Requesting Organization: Department of Environment and Conservation

Information Request No.: DEC, Wildlife Division – 2

Reference: Caribou and Their Predators Component Study; Volume 2B, Section 12.3 Caribou

Information Requested: Incorporate temporal aspects of Labrador caribou distribution into the environmental assessment.

FIGURE WD 4-2

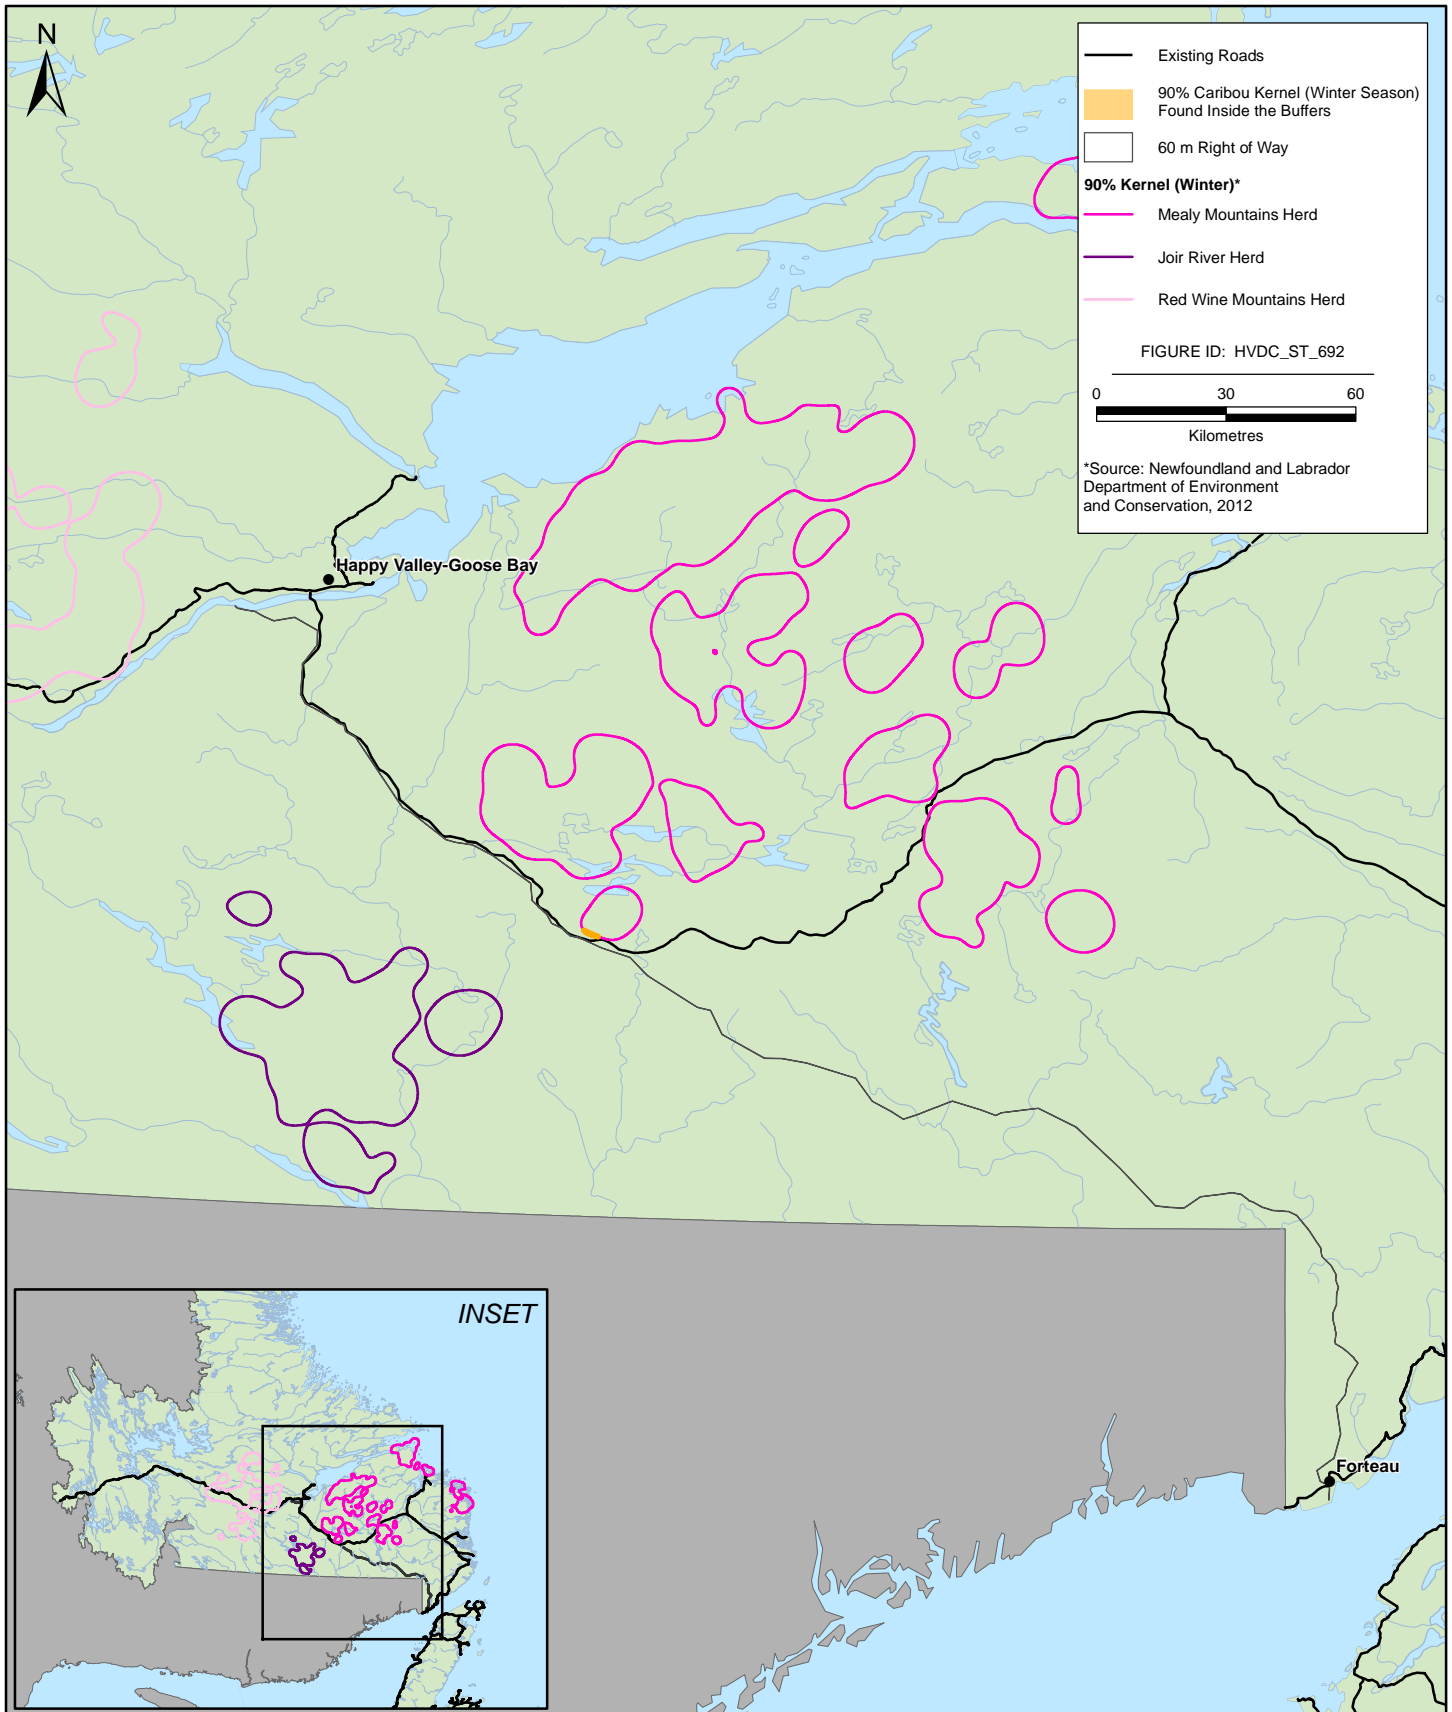
Information Requested: Range fragmentation

- Include a discussion on the effects of range fragmentation. Investigate whether the northern and southern components of the Red Wine Mountains range may become isolated from each other since the proposed transmission line will run parallel with the TLH and the river, thus potentially reducing connectivity between these portions of the range.
- Conduct a regional analysis for Labrador caribou herds to determine if there are any regional effects to caribou resulting from the project.

To further evaluate potential regional effects of the Project on Labrador caribou, Nalcor mapped the 90% probability of occupancy kernels for the caribou calving/post-calving season (Figure WD 4-1) and the winter season (Figure WD 4-2) (see the response to WD-2 and WD-3). Figure WD-4-1 and Figure WD 4-2 show that the Project right-of-way does not affect the seasonal 90% occupancy kernels for the RWM Herd or the JR Herd, and does not affect the winter 90% kernel for the MM Herd. Where the Project right-of-way lies in proximity to the winter season 90% kernels for the MM Herd, the right-of-way is on the south-west side of the TLH3 while the winter habitat use areas are to the north-east of the TLH3. The 60 m wide right-of-way does cross the calving/post-calving season 90% kernel for the MM Herd where the Project is routed along the TLH3 (i.e., an existing disturbance corridor) to avoid additional habitat fragmentation.

Based on the above information, and referring to Figure WD-4-1 and Figure WD-4-2 to provide a visual representation of the minimal overlap of the Project right-of-way with habitat during the sensitive periods of calving/post-calving and winter (see also the response to Information Request WD-2 and Information Request WD-3), regional effects (e.g., habitat fragmentation) are not likely to affect caribou populations on a regional scale (Table 12.3.7-1). The effects of the Project relative to baseline conditions are not likely to affect the viability or recovery of woodland caribou populations in Central and Southeastern Labrador and Newfoundland. Therefore, the Project is not likely to result in significant adverse environmental effects on caribou (Section 12.3.7.2, page 12-134). The information presented in this response does not affect the mitigation, findings or confidence in the conclusions of the EIS.
